ADMINISTRATIVE AMENDMENT

ADMINISTRATIVE AMENDMENT
 FILE # 16106 PROJECT # 101054L
 REVISIONS TO BLDG. (PROPOSED
 RETAIL SHELL ADDN - LEASE AREA C)
 BACKPARKING AT BLDG. ELEVATIONS + DUMPSTERS
 LANDSCAPING
 12-1-2016
 APPROVED BY _____ DATE _____

PROJECT TITLE: WEST CENTRAL PLAZA - PROP. ADDITION
 4208 CENTRAL AVE. SW ALBUQUERQUE, NEW MEXICO
 PROJECT MANAGER: STEPHEN DUNBAR, AIA
 JOB NO.: K-AT
 DRAWN BY: CRAIG C.
 SHEET TITLE: SITE DEV PLAN FOR BLDG PERMIT

Sheet Title
BUILDING FLOOR PLAN AND ELEVATIONS

SITE DEVELOPMENT PLAN FOR BUILDING PERMIT AMENDMENT
 SCALE: 1"=50'

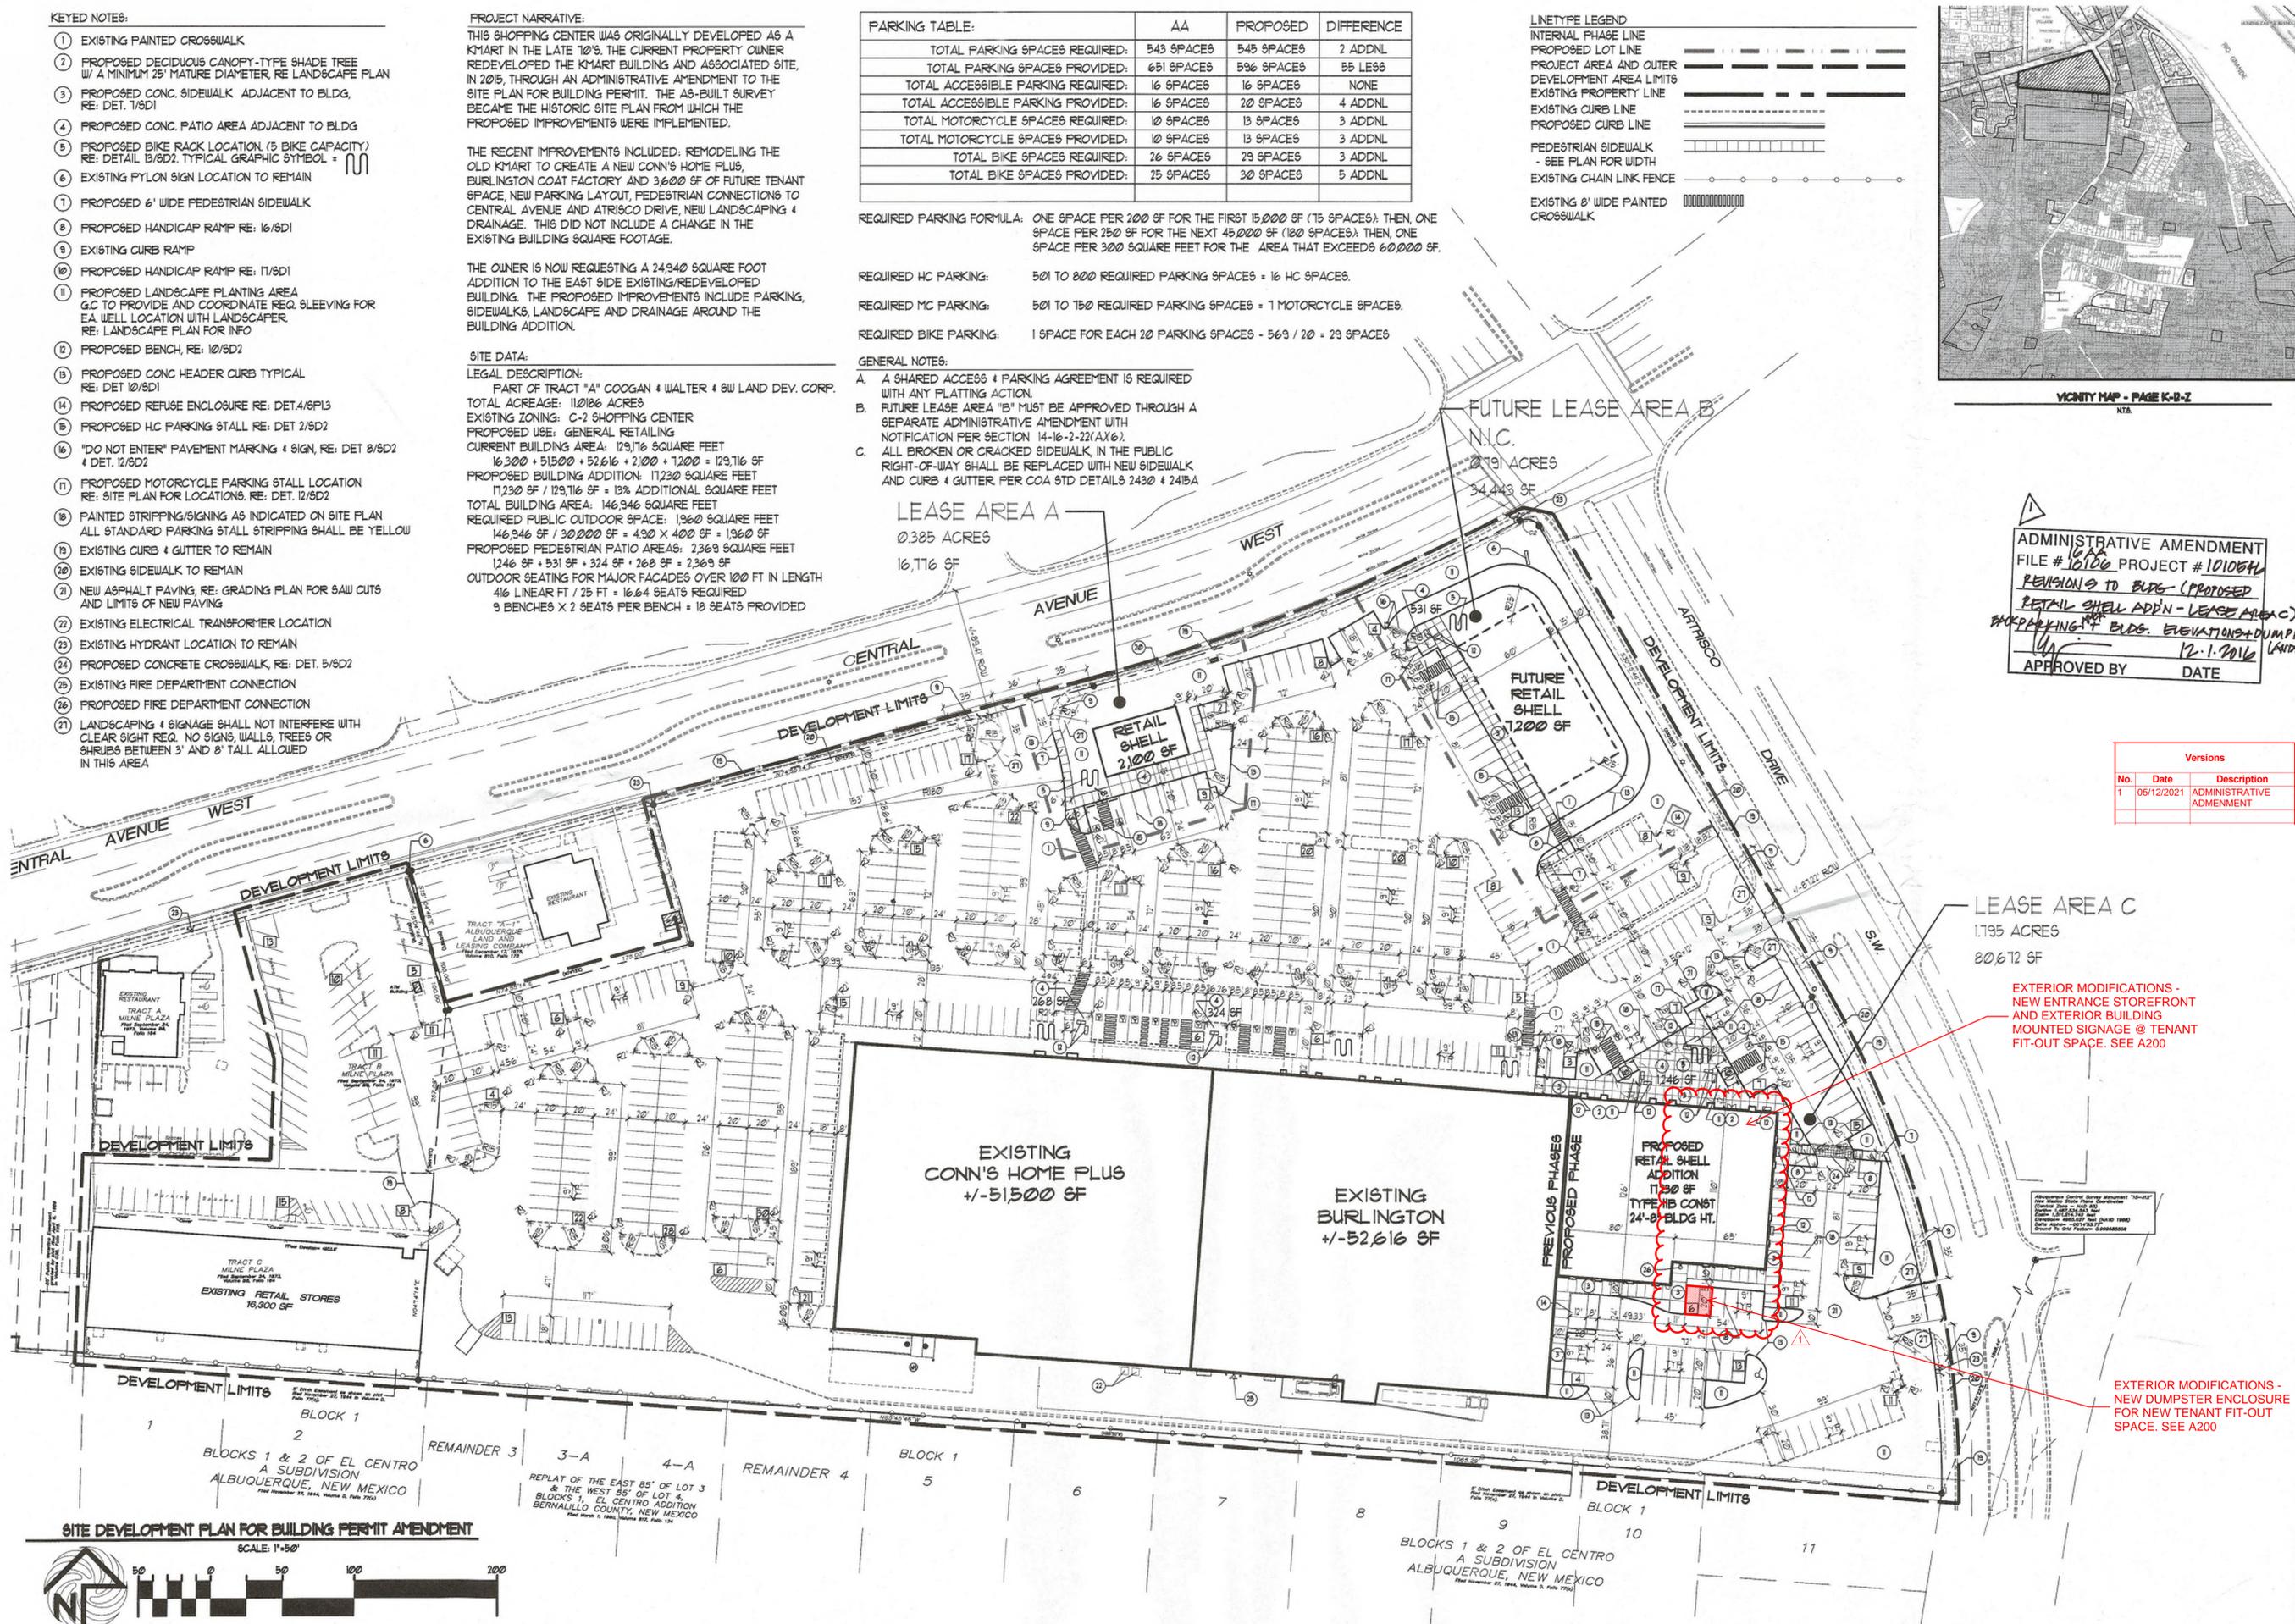
EXTERIOR MODIFICATIONS -
 NEW ENTRANCE STOREFRONT
 AND EXTERIOR BUILDING
 MOUNTED SIGNAGE @ TENANT
 FIT-OUT SPACE. SEE A200

EXTERIOR MODIFICATIONS -
 NEW DUMPSTER ENCLOSURE
 FOR NEW TENANT FIT-OUT
 SPACE. SEE A200
